RE: 13704 Ellena Gallegos NE
Grading Plan
Stamp Date: 7/18/17
Hydrology File: E24D002A

Based upon the information provided in your submittal received 8/2/2017, the Grading Plan **is not** approved for Building Permit. The following comments need to be addressed for approval of the above referenced project:

Re: Lot 95 – Unit 3 The Highlands (13704 Elena Gallegos)
Review of the Lot Specific Grading and Drainage

13704 ELENA GALLEGOS	DRAWN BY WCMJ
	GRADING AND DRAINAGE PLAN	DATE 7-16-17
	 1806 CENTRAL AVENUE SE SUITE 201 ALBUQUERQUE, NM 87106 (505) 872-0898	21740-LAYOUT-5-28-17
7/18/17		SHEET #
DAVID SOULE P.E. #14522		JOB # 21740

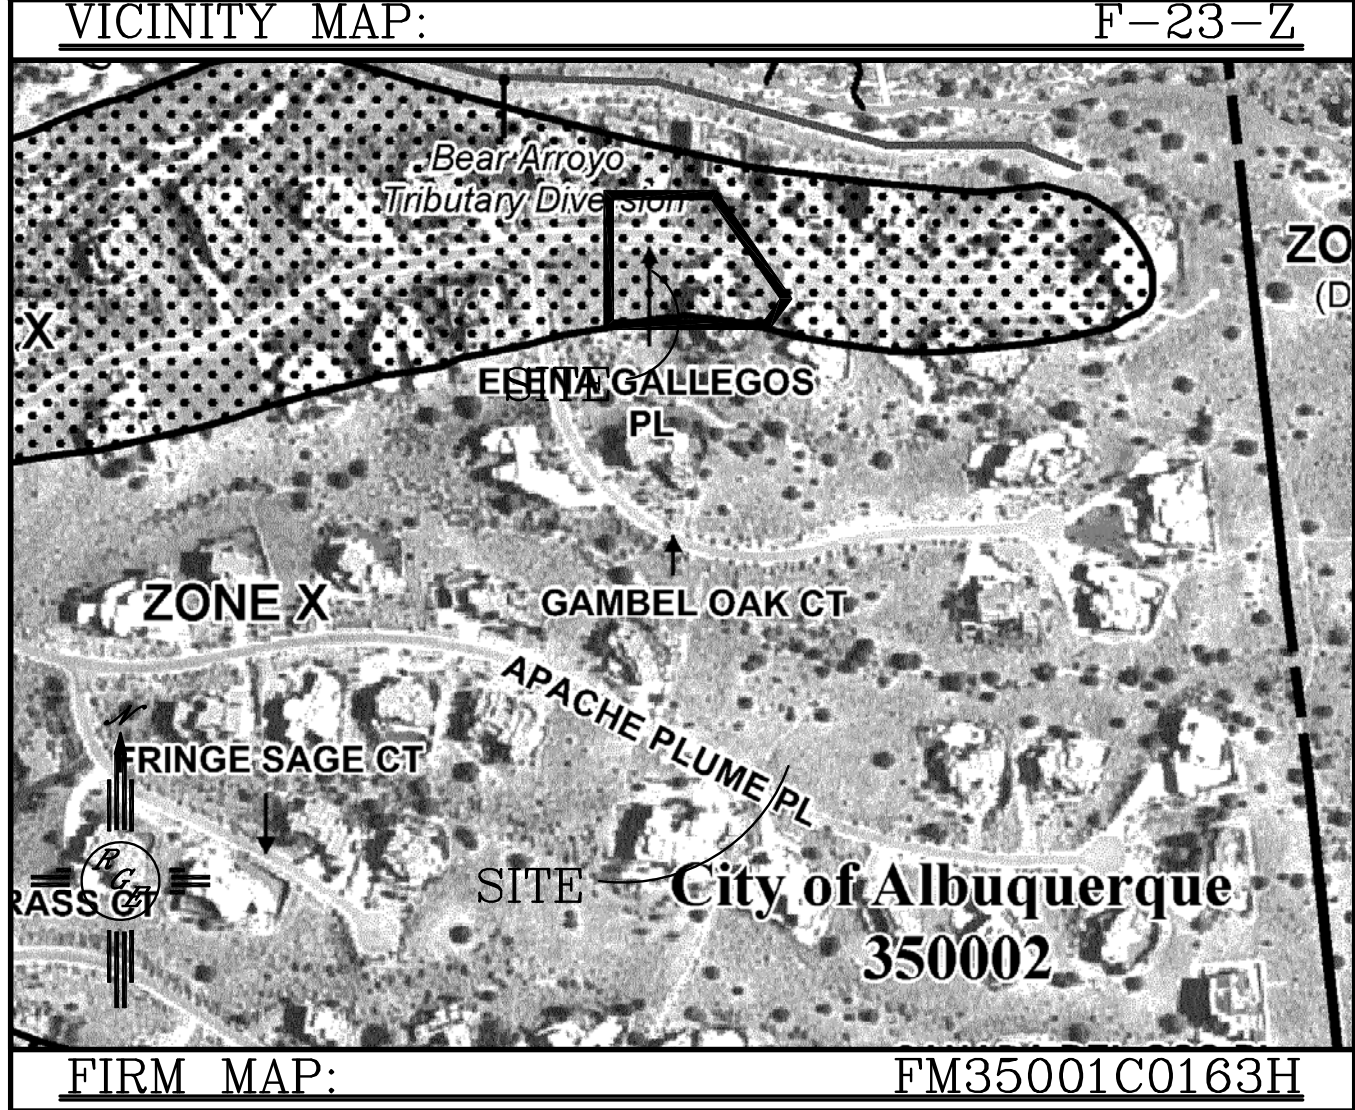
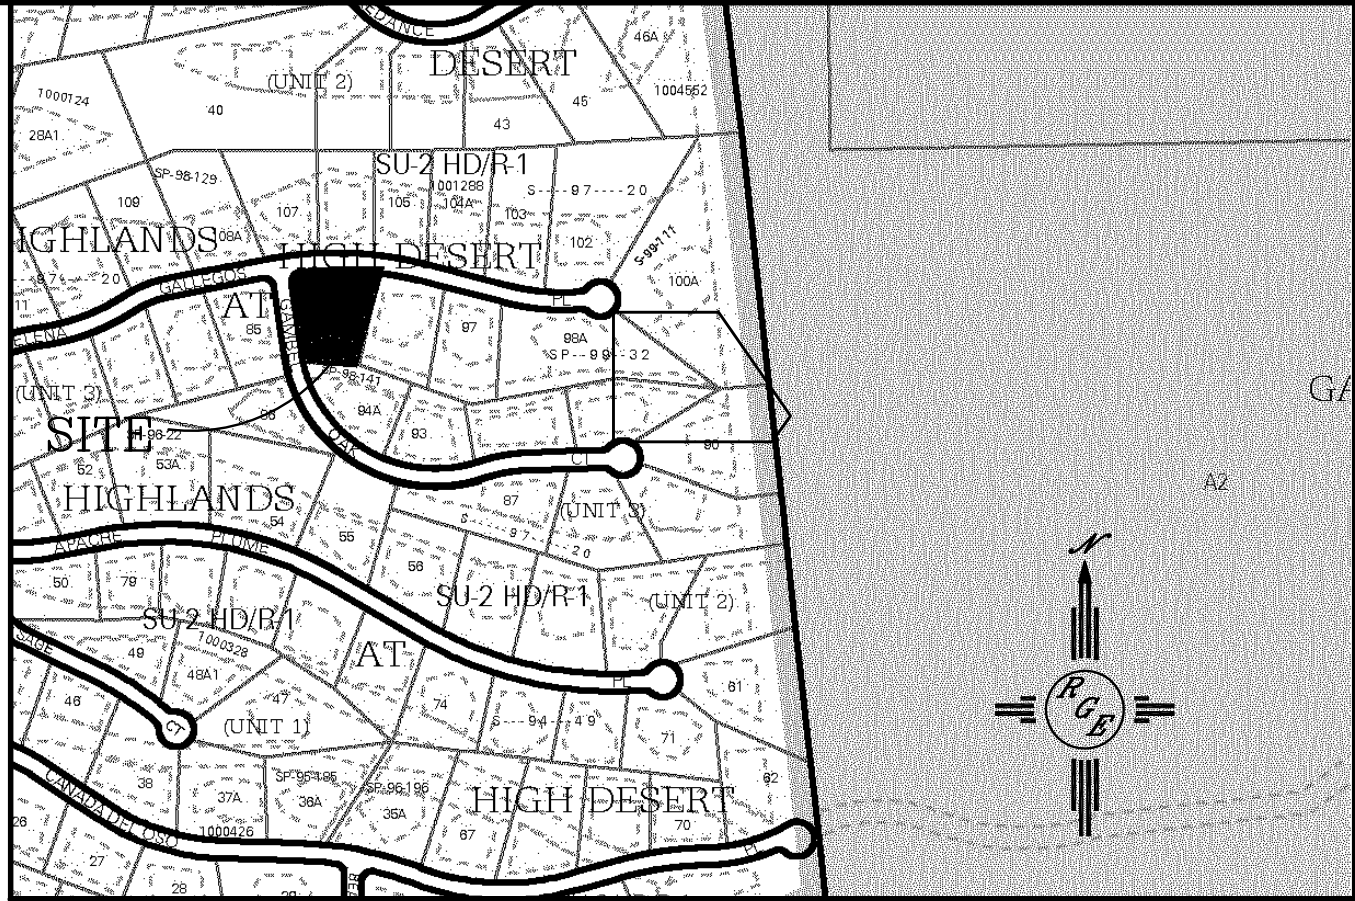
1. Please provide both the beginning and ending flowlines for all the cobble swales.
2. Please add the weir calculations for the emergency overflows.
3. There is enough room on the sheet, so please enlarge the Site Hydrology calculations and notes.

1. Please provide bench mark datum, horizontal and vertical, on the plan. **corrected**
2. Please refer to the High Desert Guidelines for Sustainability for Estate and Premier Lots for Gentle slope grading for all tieback slope within and outside the building envelope. **Site condition appear to control.**

3. The proposed flow for Basin A and B appear to be incorrect. Please review the calculations. **corrected**
4. The calculated volumes Existing and Proposed for Basins A and B appear to be incorrect. Please review calculation. This will affect the required pond volume.

5. The provided pond volume for Pond A is 3 times what is required. Why is it so larger? This is providing unnecessary disturbance. Please reduce to approximately required to reduce disturbance. **Ponds only need to detain not retain the developed flow. Consider reducing the pond sizes further to reduce disturbance and impact. However, there is more than enough volume and will have no impact to the drainage downstream**

6. On the east courtyard wall, there is an indication of a swale coming from the wall. Please provide an elevation and indication of a turned block or weep hole for drainage. **noted**

7. On the swale and pond cobble, the thickness is a minimum of 2 times the cobble size so thickness shall be 2 x 6" which is 12" not the 8" indicated. Please revise accordingly. **corrected**

8. The north pond top elevation appears to be at 73.00 not 74.00 as indicated in the note. Please correct contours, note and volume accordingly. Clearly label contours. **corrected**

9. How is the south swale tie to slope at the bridge? It appears you are tying to the abutment\wingwall. This could cause erosion at the structure. The natural lowpoint appears to be to the east. Consider moving spillway and swale to that location to stay away for the bridge abutment. **corrected**

10. Please label the lowest natural grade on the building footprint for reference.
corrected

Based on the revised grading and drainage plan for the above referenced Lot stamped dated 7/18/17 by Rio Grande Engineering. It appears that all the comments have been substantially addressed in regards to the grading and drainage.
